# UNITED STATES PATENT AND TRADEMARK OFFICE

APPLICATION NO.	FILING DATE	FIRST NAMED INVENTOR	ATTORNEY DOCKET NO.	CONFIRMATION NO.
10/699,335	10/31/2003	Anthony J. Cafferata	J-3763	5399
28165	7590	10/31/2005		
S.C. JOHNSON & SON, INC. 1525 HOWE STREET RACINE, WI 53403-2236			EXAMINER FIDEI, DAVID	
			ART UNIT	PAPER NUMBER

<b>Office Action Summary</b>	<b>Application No.</b>	<b>Applicant(s)</b>	
	10/699,335	CAFFERATA ET AL.	
	<b>Examiner</b>	<b>Art Unit</b>	
	David T. Fidei	3728

## DETAILED ACTION

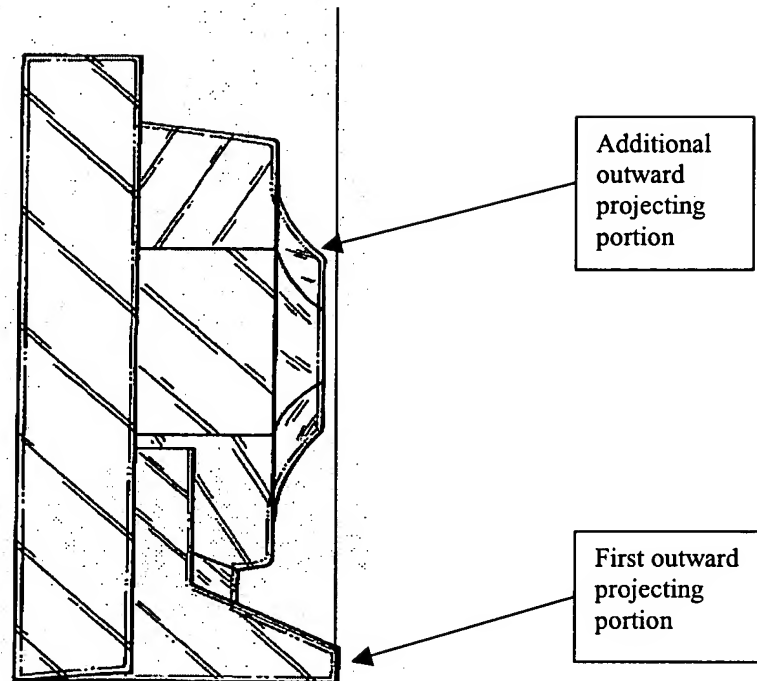
10. Claims 1-14 are rejected under 35 U.S.C. 102(b) as being anticipated by Humphrey (Patent no. D447,408). As to claims 1 and 2 a package for containing and displaying at is disclosed comprising a back panel, and a front panel attached to said back panel, wherein said front panel comprises a blister pack formed of plastic and including a first outward projecting portion in a bottom portion of said blister pack and at least one additional outward projecting portion having a depth and shape conforming to at least a portion of said at least one article, wherein at least a portion said first outward projecting portion extends widthwise at least a substantial portion between a first side of said blister pack and a second side of said blister pack, and has a depth outward sufficient to allow said package to stand substantially upright. As shown by the figure below the depth of said at least a portion of said first outward projecting portion is equal to or greater than an outermost projecting portion of the depth of said at least one additional outward projecting portion

As to claim 3, a package is shown above according to claim 1 wherein said at least one additional outward projecting portion is continuous with said first outward projecting portion.

As to claim 4, a blister pack according to claim 2 is shown wherein said at least one additional outward projecting portion is continuous with said first outward projecting portion.

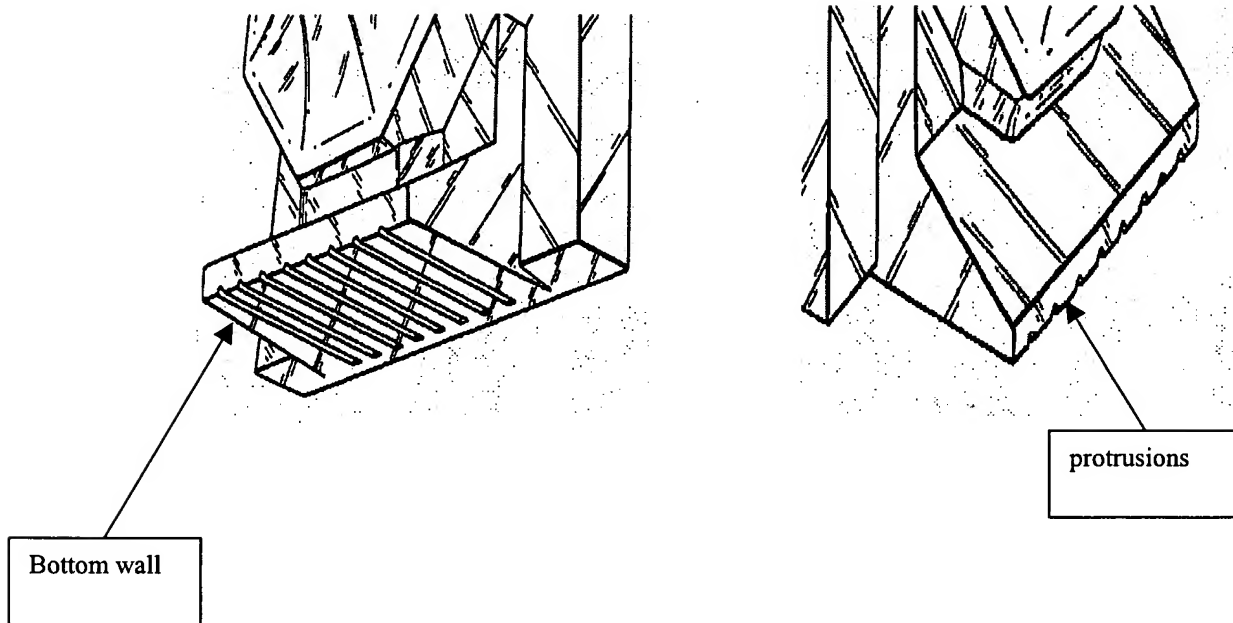
As to claim 5, a package according to claim 1 wherein said first outward projecting portion includes a bottom wall having integral therein at least two spaced apart downward protrusions, see the figure below

As to claim 6, a blister pack is shown according to claim 2 wherein said first outward projecting portion includes a bottom wall having integral therein at least two spaced apart downward protrusions. As shown above there are a plurality of protrusions in as much as is claimed.

As to claims 13 and 14, the at least one additional outward projecting portion is equal in depth to the depth greatest in the first outward projecting portion and a portion of said depth of

said at least one additional outward projecting portion is of lesser depth than the depth greatest in the first outward projecting portion as shown by the vertical line in the figure on page 5.

**FIG. 1**

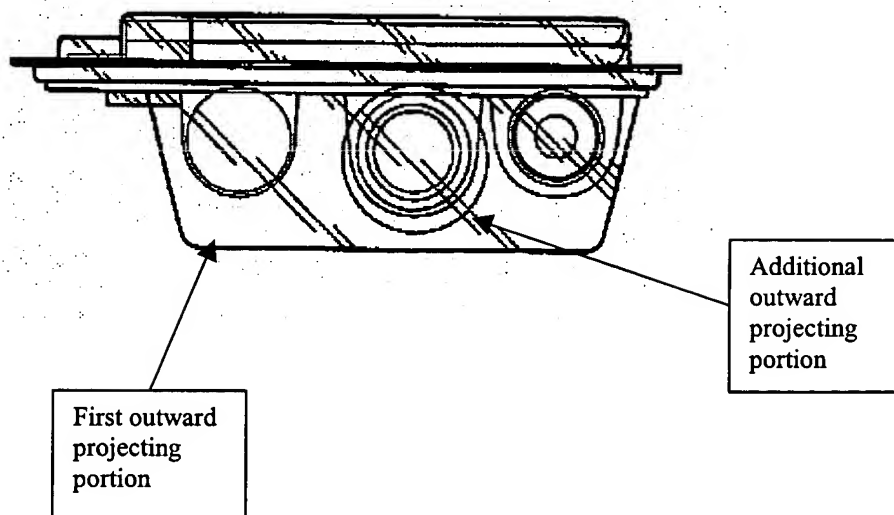
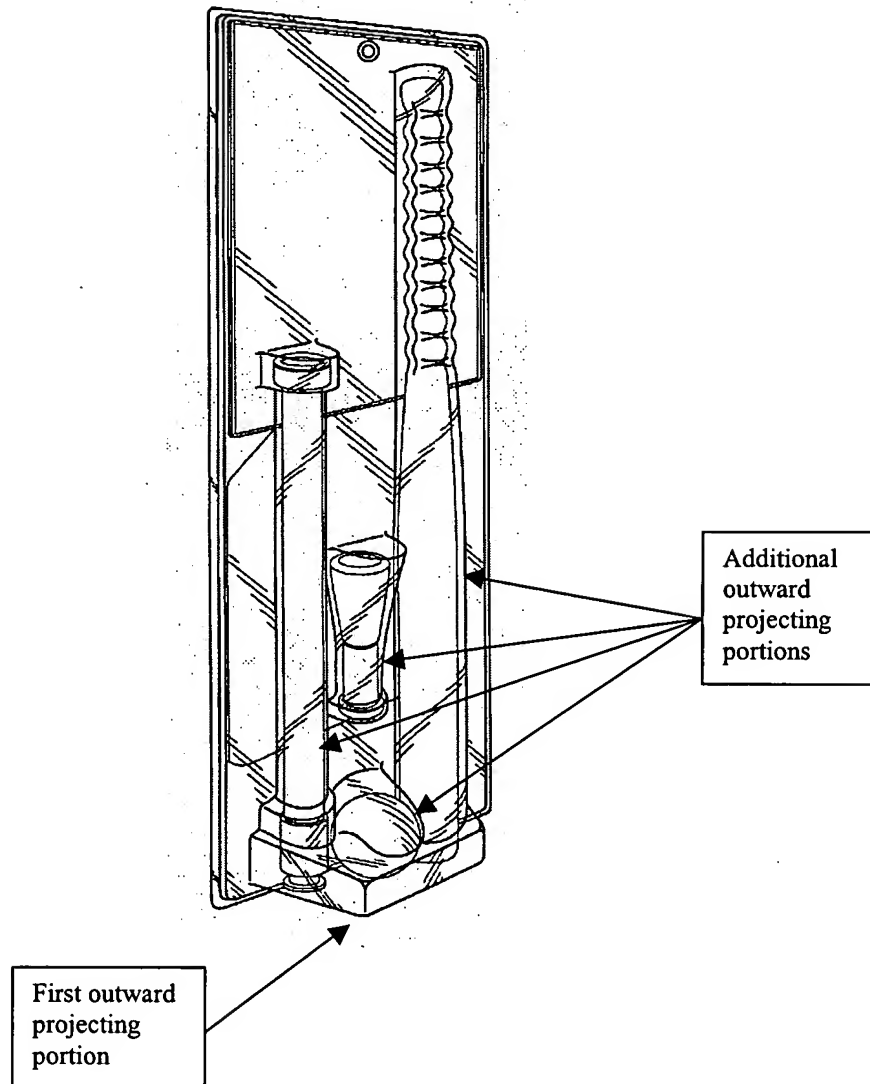
11. Claims 1-4, and 7-16 are rejected under 35 U.S.C. 102(e) as being anticipated by Udwin et al (Patent no. D467,494). As to claims 1 and 2 a package for containing and displaying at is disclosed comprising a back panel, and a front panel attached to said back panel, wherein said front panel comprises a blister pack formed of plastic and including a first outward projecting portion in a bottom portion of said blister pack and at least one additional outward projecting portion having a depth and shape conforming to at least a portion of said at least one article, wherein at least a portion said first outward projecting portion extends widthwise at least a substantial portion between a first side of said blister pack and a second side of said blister pack, and has a depth outward sufficient to allow said package to stand substantially upright. As shown by the figure below the depth of said at least a portion of said first outward projecting portion is equal to or greater than an outermost projecting portion of the depth of said at least one additional outward projecting portion

As to claims 3 and 4, a package is shown above according to claims 1 and 2 wherein said at least one additional outward projecting portion is continuous with said first outward projecting portion.

As to claims 11 and 12, the first portion is substantially rectangular when view from the figure on the previous page in as much as is claimed.

As to claims 13 and 14, the at least one additional outward projecting portion is equal in depth to the depth greatest in the first outward projecting portion and a portion of said depth of said at least one additional outward projecting portion is of lesser depth than the depth greatest in the first outward projecting portion as shown by the vertical line in the figure on page 7.

As to claim 15 and 16, a package is shown in the figure on page 7 where said at least one additional outward projecting portions are present, on either side of the middle additional projection portion, wherein said two of said at least two additional outward projecting portions are of different depths from each other.
